Remote Link and System Link December 2011

Version 1.61 Software Update

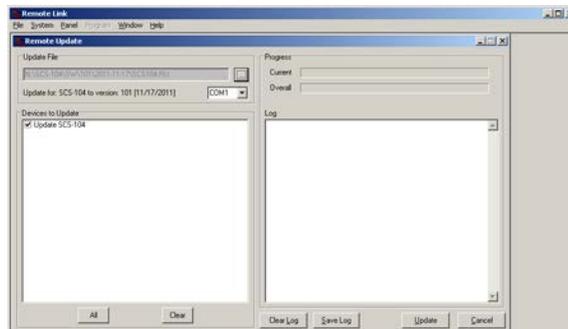
For XR100/XR500 panels with software Version 208 (9/7/11) or higher, Remote Link now displays and prints the cellular signal strength value stored in Display Events when a cellular path has failed to communicate. This signal strength, sent as a -dbm value, is the strength value at the time the communication trouble occurred. The path restoral also includes the signal strength value.

In addition, an Automatic Recall Test or an Automatic Recall Test - Unrestored System include the cellular signal strength value. Printout Examples:

- S72: WARNING: Path 1 Cell Primary Trouble (-96 dBm)
- S73: Path 2 Cell Backup Restored (-71 dBm)
- S07: Path 1 Primary Cell Automatic Recall Test OK (-76 dBm)
- S88: Path 2 Primary Cell Automatic Recall OK - Unrestored System (-74 dBm)
